**SUBJECT: COOPER NUCLEAR STATION - NRC SPECIAL INSPECTION
REPORT 05000298/2005014**

IR 05000298/2005014; 10/17/05 - 12/01/05; Cooper Nuclear Station. Other Activities.

SUBJECT: SPECIAL INSPECTION CHARTER TO EVALUATE MOTOR STARTER
FAILURES AT COOPER NUCLEAR STATION

Figure 1: Typical Westinghouse Full Voltage, Reversing Starter Assembly, NEMA Class 1

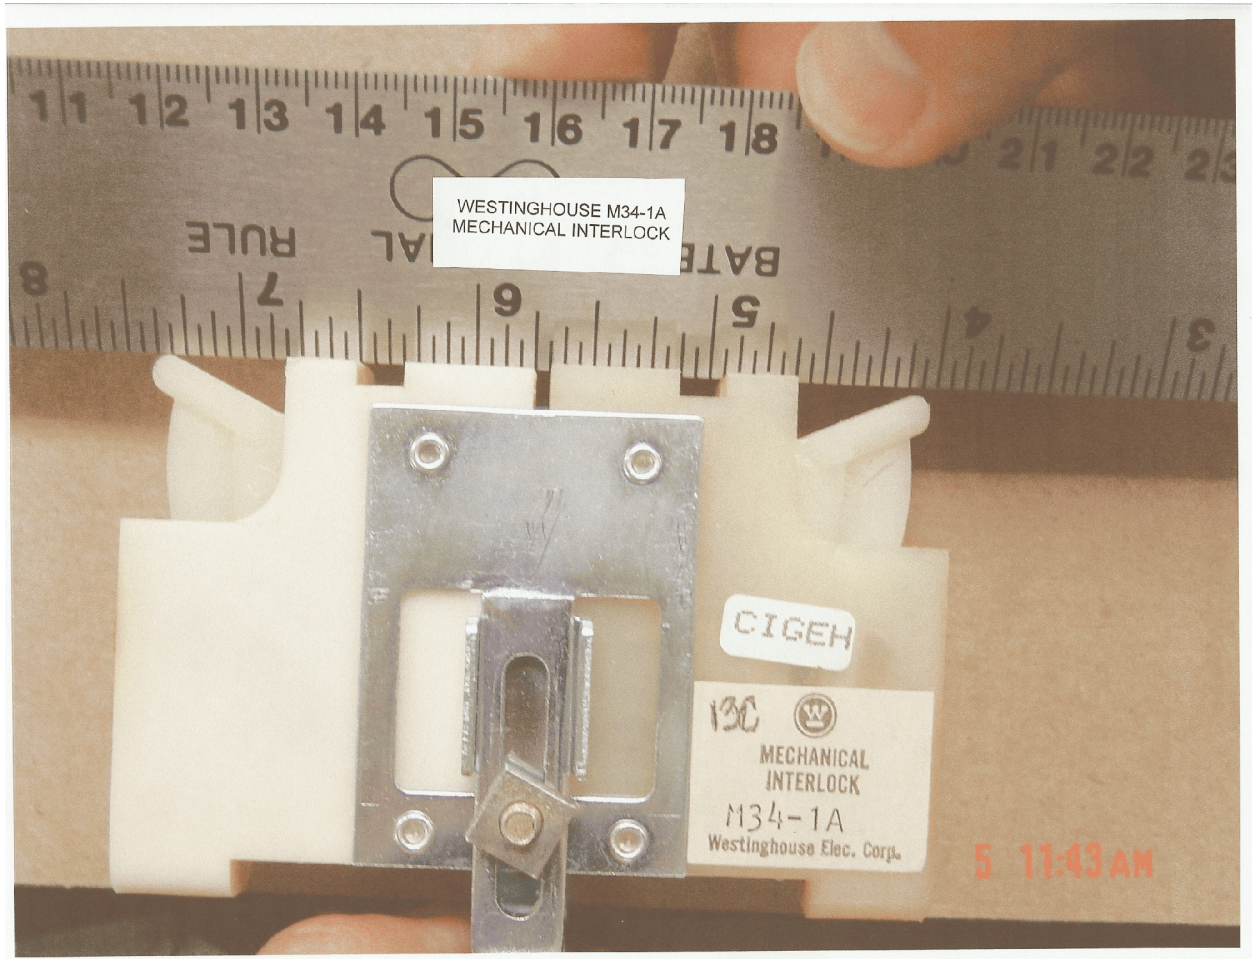
RHR-MOV-MO13C and RHR-MOV-MO15B are safety-related MOVs, which are controlled by full voltage, reversing motor starters located in MCC Q and MCC Y, respectively. Both of these MCCs are located inside the reactor building. These starter assemblies were manufactured by Westinghouse Electric Corporation and were installed between 1986 and 1988. There are approximately 100 additional safety-related valves in the plant with identical starter assemblies. The starters contain two sets of contactors, each of which energize to operate the valve in the open or close direction. A mechanical interlock is installed between the contactors to prevent both sets of contactors from closing at the same time, which could cause damage to the valve actuator motor. The interlock also provides assurance against inadvertent valve actuation during a seismic event and serves as a time delay mechanism between the open and close strokes of a valve to provide additional electrical protection for valve actuator components. Figures 1 and 2 show a typical starter assembly and mechanical interlock.

During troubleshooting on RHR-MOV-MO13C and RHR-MOV-MO15B, the licensee determined that the mechanical interlock between the contactors in each of the starter assemblies was deformed. This deformation caused the interlock to bind such that when a valve operation was demanded from the control room, the associated contactor would energize but would not have sufficient force to move the interlock. In the case of RHR-MOV-MO13C, this binding caused the close contactor to remain energized in an attempt to close the valve until it overheated, causing the control power fuse to open. In the case of RHR-MOV-MO15B, the successful operation of the valve on the second attempt indicated that the failure mechanism was intermittent in nature. The licensee also determined the most likely cause for the deformation was a manufacturing issue with the starter assemblies. The interlock is mounted to the backplate of the starter assembly with an "L" bracket which is held in place by a single screw. The mounting holes for the interlocks in these two starter assemblies were off-center; therefore, external force had to be applied to the edges of the interlocks in order to mount them using these holes. Over time, the external force caused stress relaxation in the nylon plastic case of the interlock, which resulted in misalignment of the internal components and caused the interlock to bind.

Figure 2: Westinghouse M34-1A Mechanical Interlock

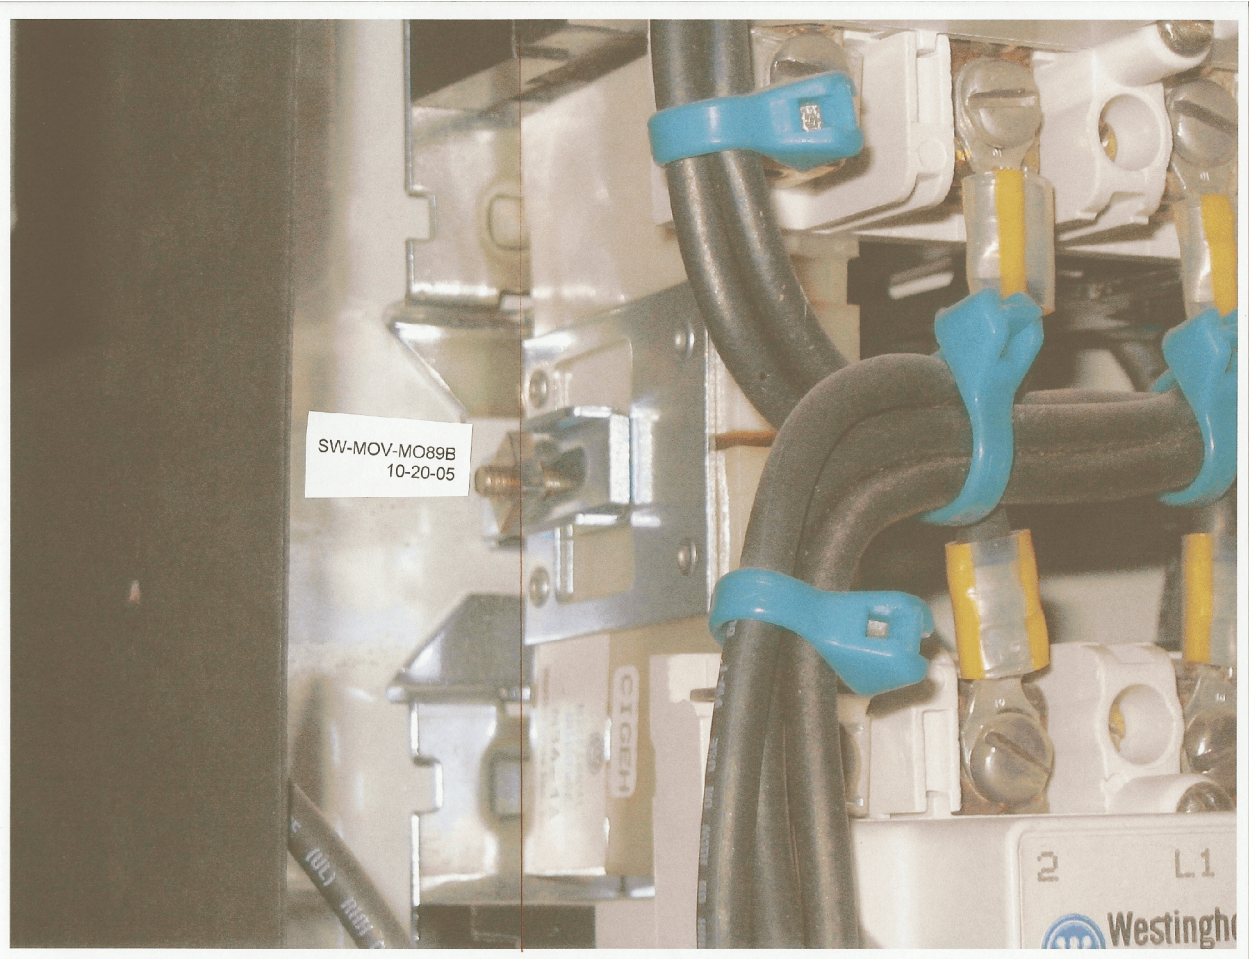
Details. As an immediate corrective action for the interlock binding issue, the licensee determined that the mechanical interlocks in the starter assemblies for RHR-MOV-MO13C and RHR-MOV-MO15B should be replaced with new interlocks that were mounted in a manner that ensured no external forces were applied to their cases. In order to realign them to the desired condition, the licensee rotated the interlocks 180E and drilled new mounting holes in the backplate of the assembly which allowed installation of the interlock "L" brackets such that no external forces would be applied to interlock cases. This work was accomplished on September 25 using Maintenance Work Orders 4454157 (RHR-MOV-MO15B) and 4463594 (RHR-MOV-MO13C).

The inspector questioned the adequacy of this unauthorized modification and, as a result, the licensee performed additional corrective maintenance on the starter assemblies which entailed loosening the mounting screws and re-tightening them using 19 in-lbs of torque. No as-found torque values were obtained during this work so the licensee was unable to assess the actual impact on the seismic qualification of the starter assemblies. In addition, the licensee reviewed this modification against the requirements of 10 CFR 50.59 and determined that prior NRC approval would not have been required for this modification. The licensee also verified the technical adequacy of the modification with the original equipment manufacturer, who concurred with the modification.
